Ordinary Meeting of Council

ITEM 8.3 DEVELOPMENT APPLICATION 71-2016 FOR SMALL LOT

ATTACHMENT 1 COUNCIL MEETING - 26 OCTOBER 2016 - DA 71-2016 -

ATTACHMENT - SECTION 79C(1) TABLE - Matters For Consideration

Figure 1 – Proposed fencing

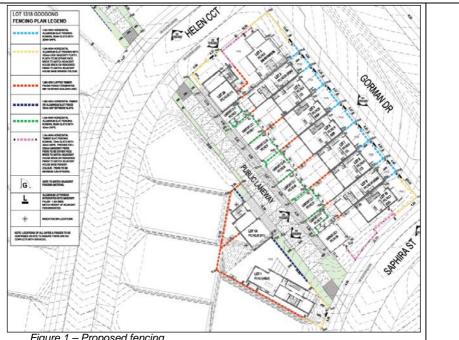
The submitted landscape plans define the public/private space with plantings and the following fencing types. See figure 1 below:

plinth to front and side corners of dwellings 1, 2, 2A and, 10. Plan will be amended in red to delete the 1.0m high fence to the front and side of dwelling on Lot 1. This will make the narrow frontage of Lot 1 seems wider.
